ELECTRIC CHAIN GRIDDLE
ECGM SERIES

ECGM-24S, ECGM-36S, ECGM-48S, ECGM-60S

PARTS LIST

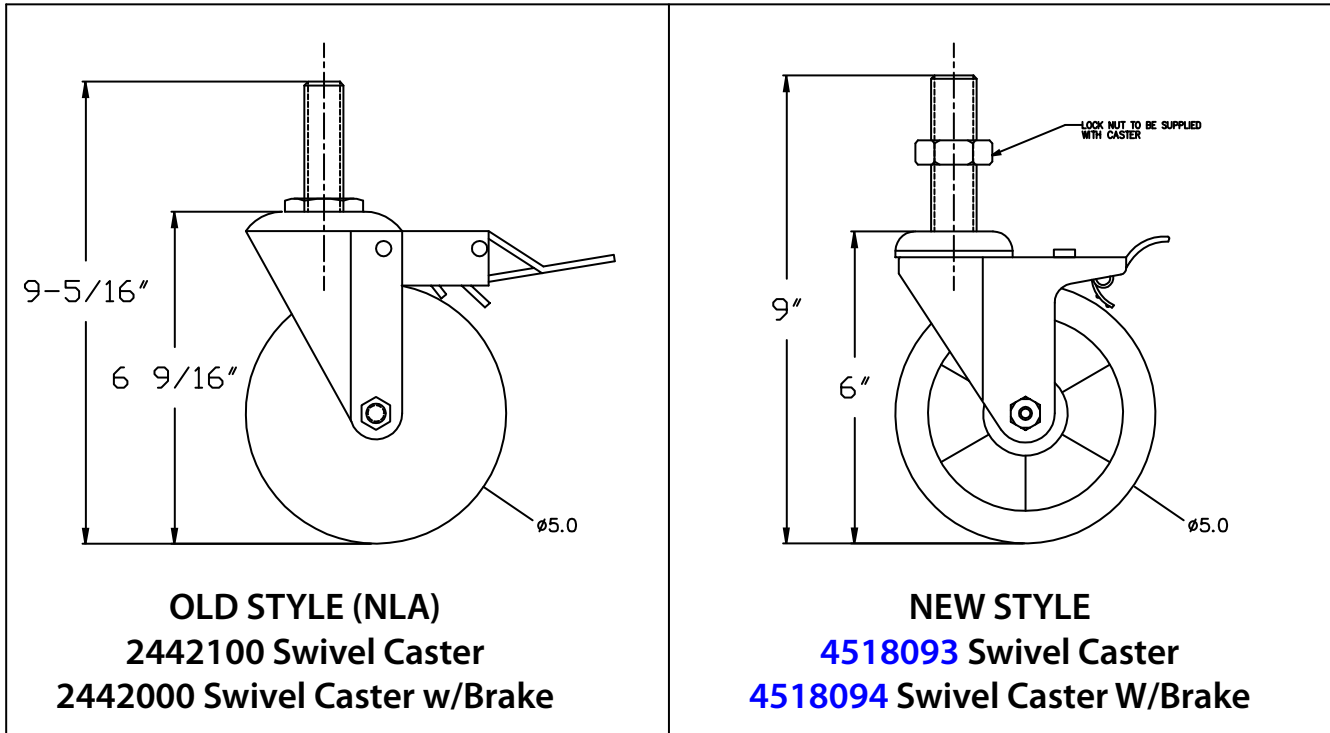
Please note that there are differences between the old and new casters, The new casters are .312" (5/16) shorter overall so in this case, would not be interchangeable. When replacing the old caster Garland highly recommends replacing all remaining casters with the new caster. both new and old casters use (5") diameter wheels.

First unit manufactured with the new casters:
Model: CG-72R-0004
Serial Number: 0410100108836
Implementation Date: October 25/2004
